Red Pit, Dilton Marsh

Transport Note: Further Information for Highway Authority

Document Reference: **C23110/TN02**

- 1.1.2 The TN provides further information in response to comments from Wiltshire Council's Highway Development Control dated 16th September 2025 provided in its role as the local highway authority (LHA).

Figure 2-1: Existing Public Rights of Way

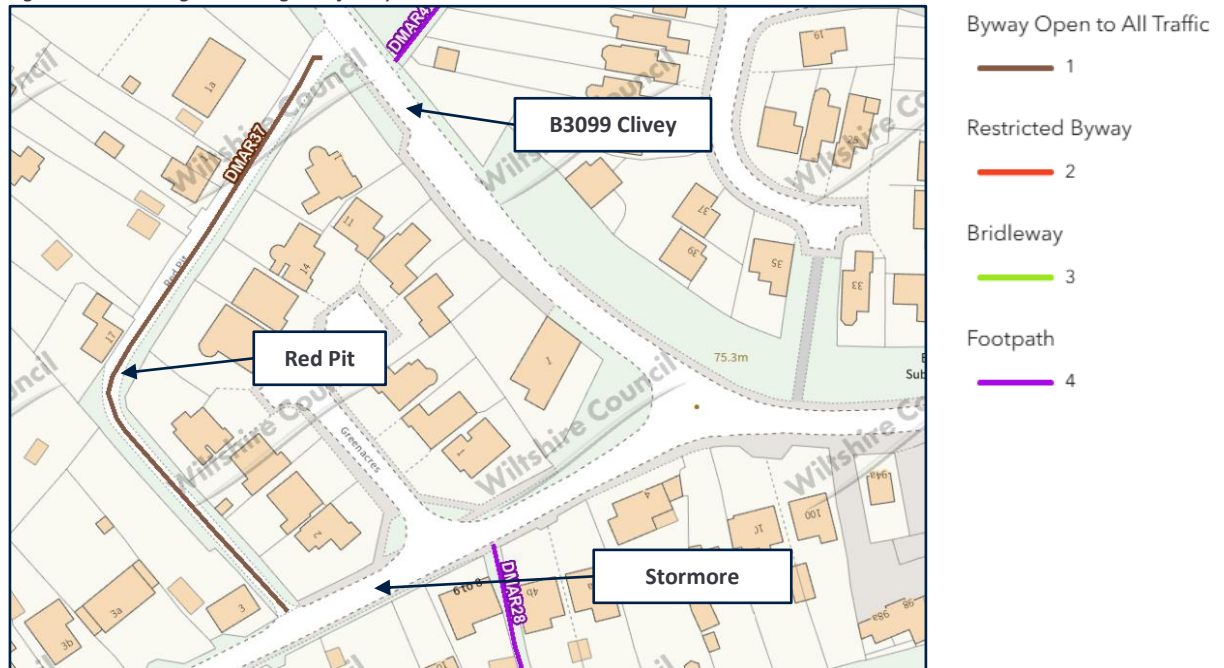
"The proposed development would result in an increase in vehicular traffic along Red Pit, a track with designated public rights (Byway DMAR37) with consequent loss of amenity and risk of additional hazard and inconvenience to all users of the designated right of way".

- 2.1.3 We agree that Red Pit between the B3099 and Stormore is a Byway Open to All Traffic (BOAT), known as route DMAR37 as shown at Figure 2-1. A BOAT is a public right of way legally designated for all types of traffic, including pedestrians, cyclists, horse riders, and mechanically propelled vehicles.

- 2.1.8 A public byway can legally cross over private land, as PROWs are routes the public can use at all times, even if the land itself is owned privately. The landowner(s) must not obstruct or interfere with these rights, and any user of a route (BOAT in this instance) has a responsibility to be mindful of the private property they are crossing.

- 2.1.9 There are no physical gates at either end of Red Pit, which would prevent access for users of the BOAT and as such, there is no ‘loss of amenity’ to that effect.

Figure 2-2: Wiltshire Council Adopted Highway Extent

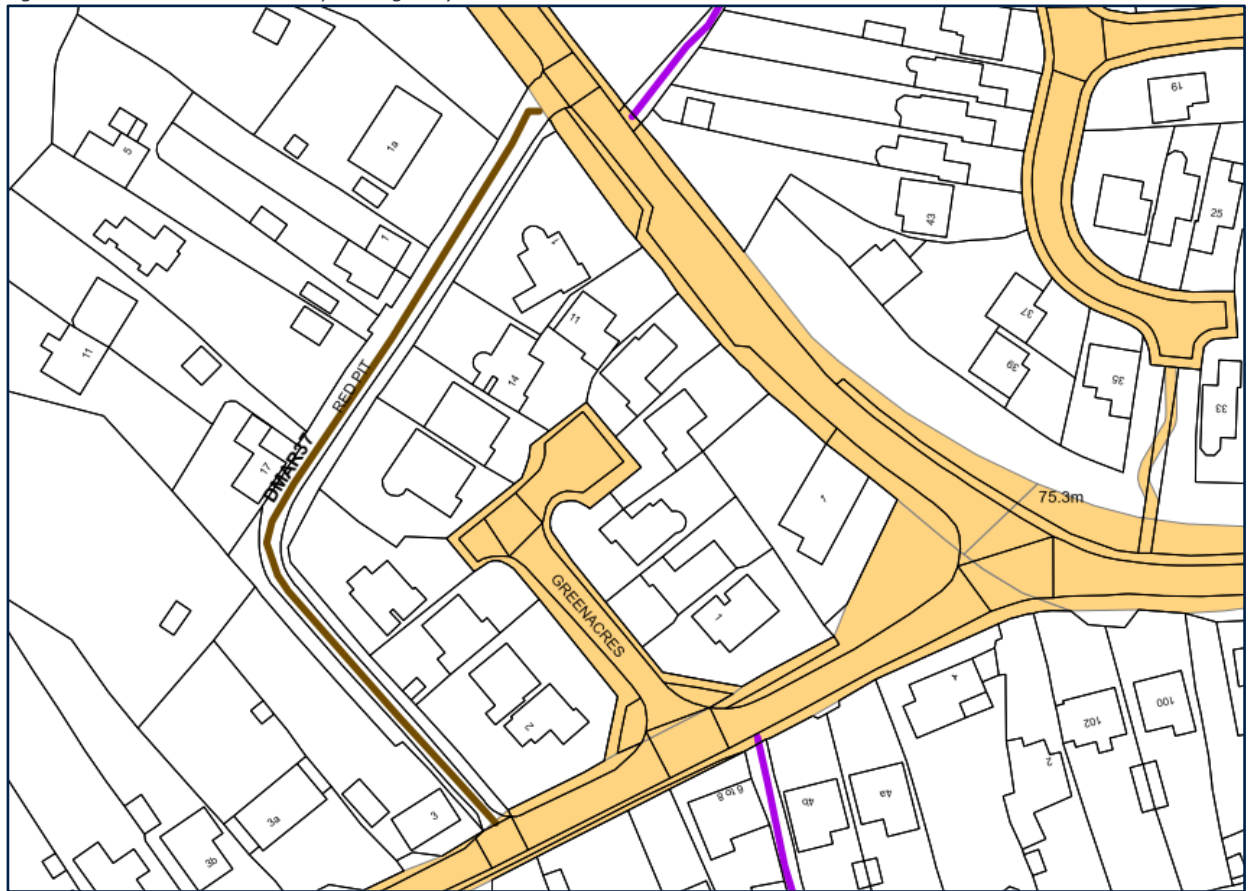
"Red Pit is not of the condition nor is maintained to the standard necessary to accommodate the volume and type of traffic likely to be generated by the development proposed. The proposed increase in use would lead to further deterioration".

- 2.1.7 This establishes that Red Pit is private and does not form part of the ‘adopted’ highway (shown highlighted yellow), whereby Red Pit could be managed, altered, improved or controlled by the Local Highway Authority.

- 2.2.1 It is established that Red Pit does not form part of the adopted highway network (Figure 2-2), however, access must be 'maintained' along the length of Red Pit as it does form Wiltshire Council route DMAR37, which is a BOAT.

- 2.2.2 As such, the 'condition' of Red Pit cannot be 'maintained' by the LHA in the physical sense for improvements such as surfacing as it is under private ownership. Therefore, the landowner(s) of Red Pit, could at any point make improvements to the existing 'condition' of Red Pit.

RED PITT, DILTON MARSH - EXISTING
STORMORE ACCESS VISIBILITY SPLAYS

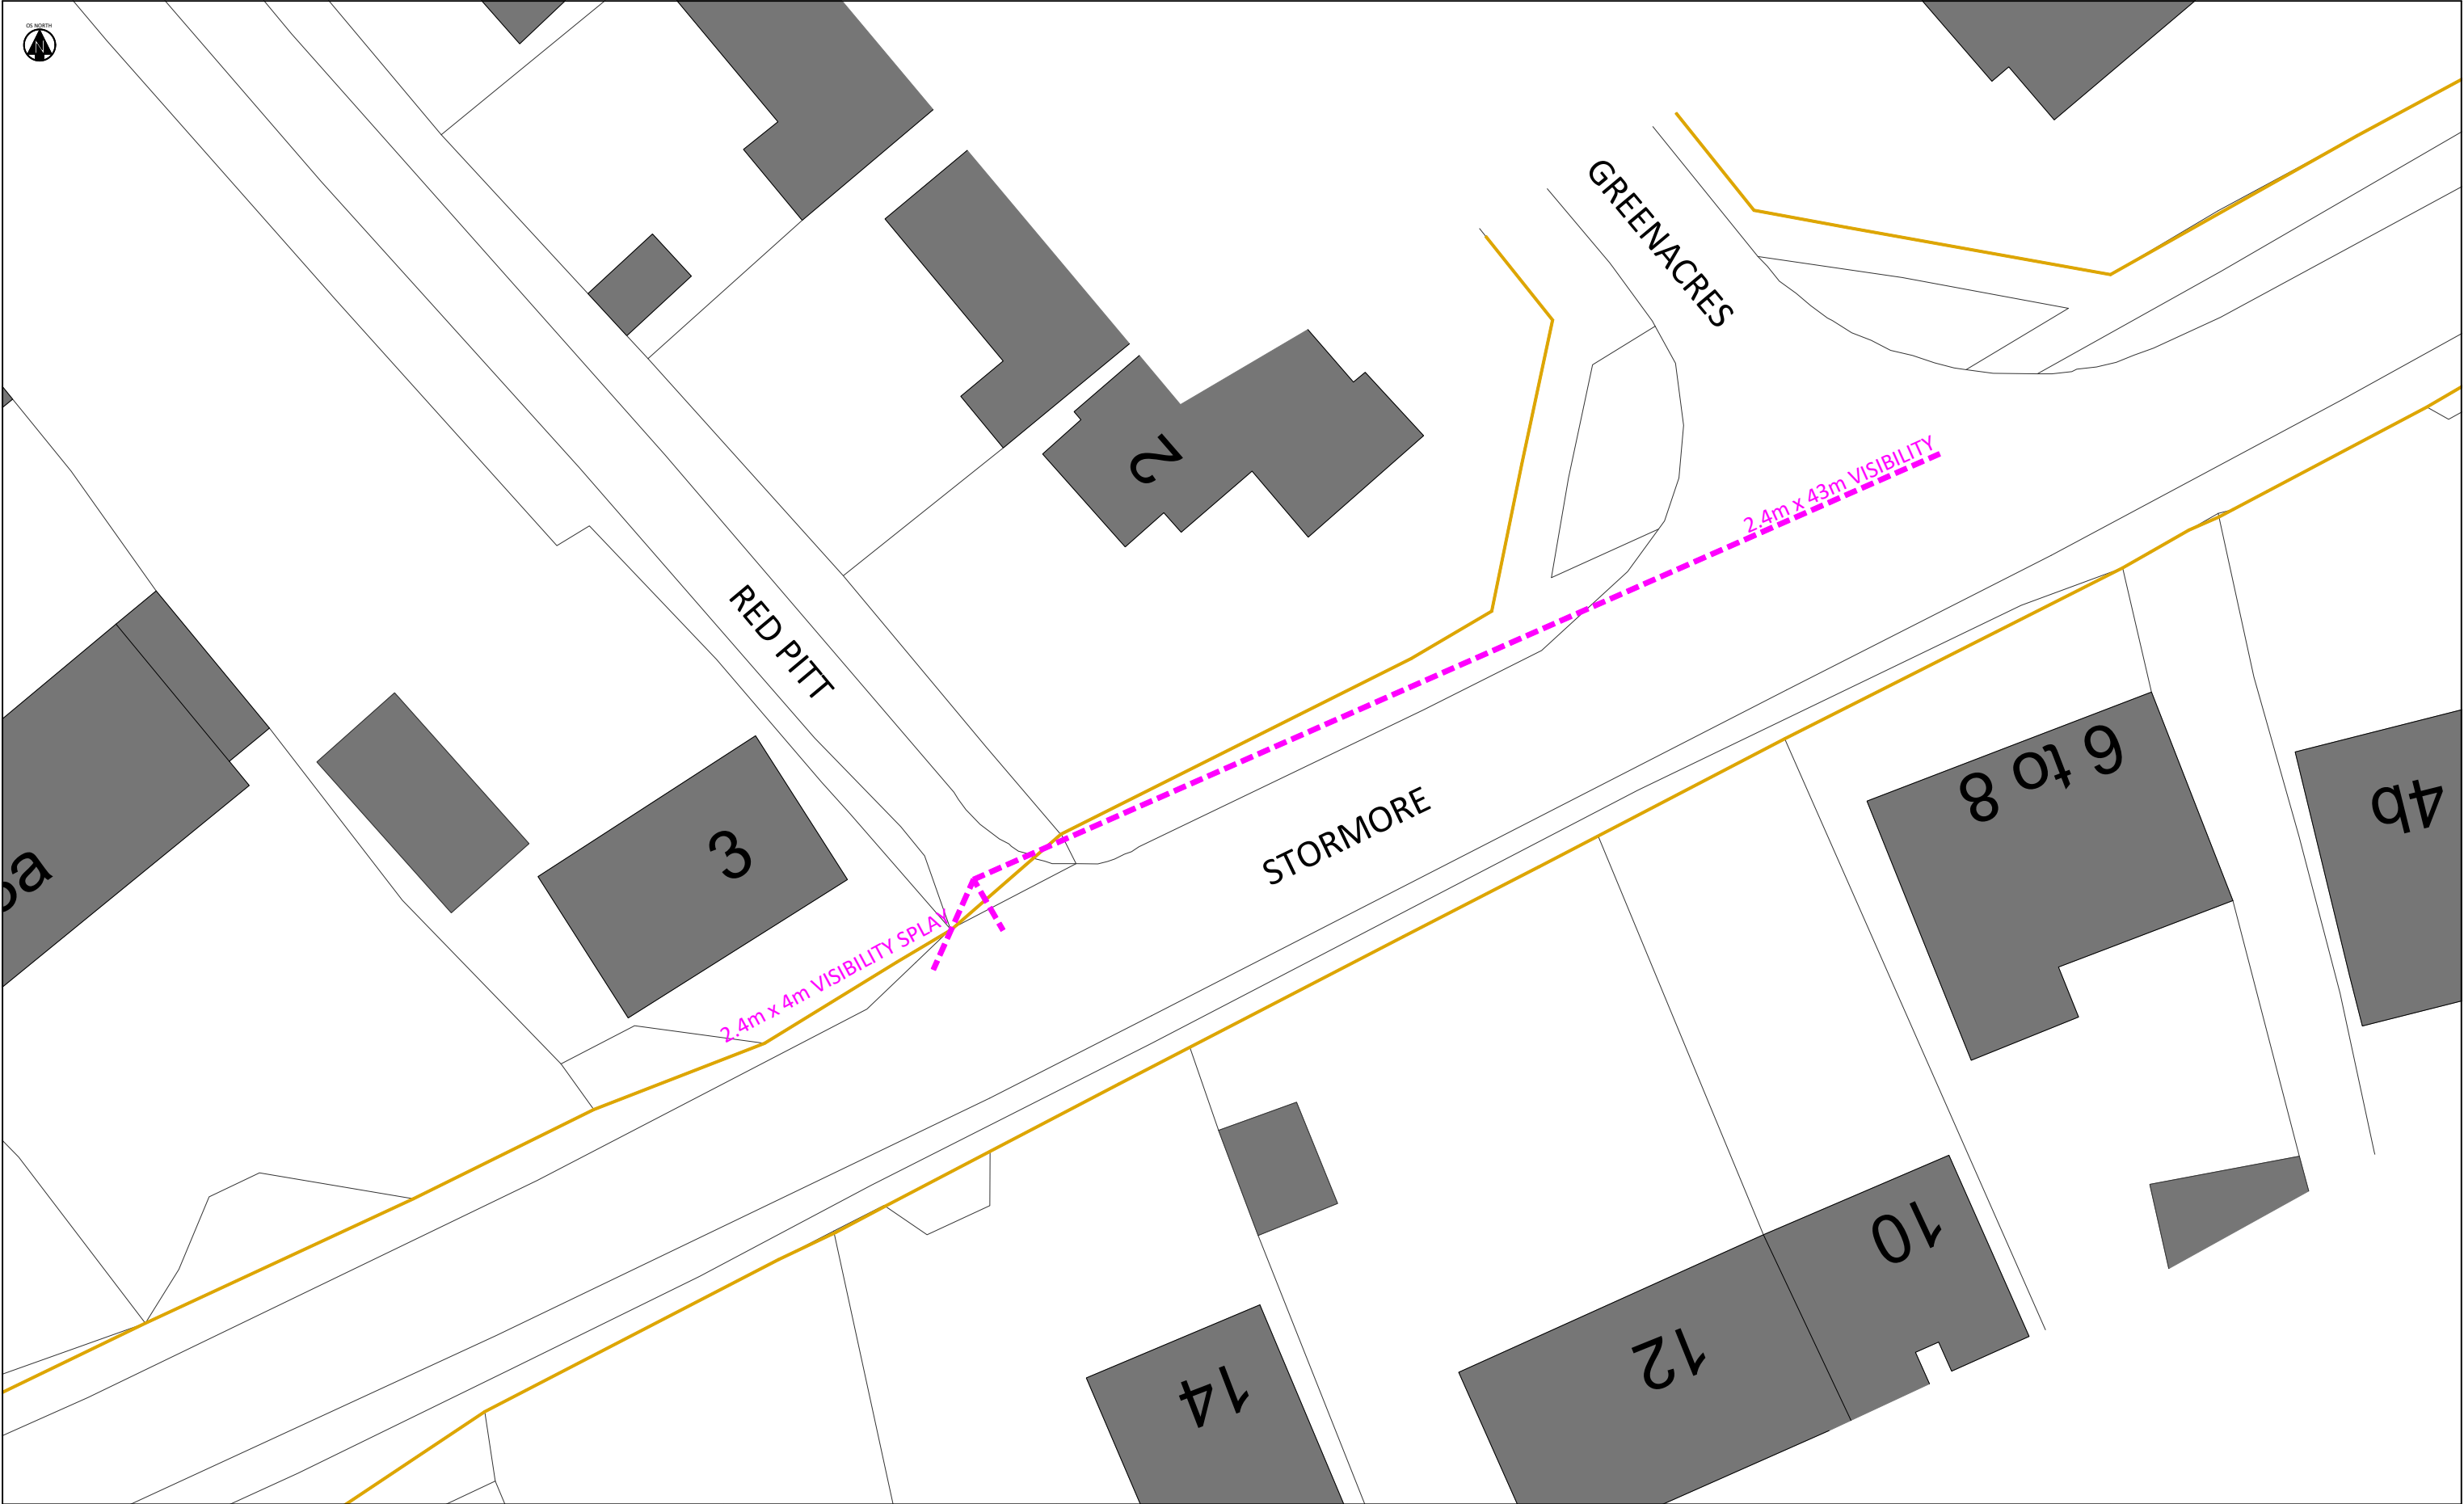
"The applicant has not demonstrated that sufficient visibility splays in both directions are available / achievable from Red Pit onto the B3099 Clivey road or onto Stormore".

The junction of Red Pit with Stormore is substandard in terms of width and visibility particularly to the right (west) where the sight line is obscured by the garden wall of the adjacent property. Visibility at the junction on to the B3099 appears appropriate, although the splay to the left (northwest) falls predominantly within the national speed limit and must be measured accordingly, speed surveys could be useful to determine appropriate splays.

- 2.4.3 At the access with Stormore, drivers are provided with 2.4m x 4m to the nearside carriageway edge to the west, which is restricted due to third-party land/a boundary wall. To the east drivers are provided with 2.4m x 43m to the east to the nearside carriageway edge, which is in line with MfS guidance for the existing 30mph speed limit.

- 2.4.4 However, whilst both existing junctions do not fully meet guidance for vehicular visibility, in practice both operate safely where trips generated by existing properties utilise each access point from Red Pit. Section 2.3 of TN01 demonstrated that along Red Pit or at its junctions with the B3099 Clivey and Stormore there is no evidence of a recorded Personal Injury Accident (PIA). The study period included
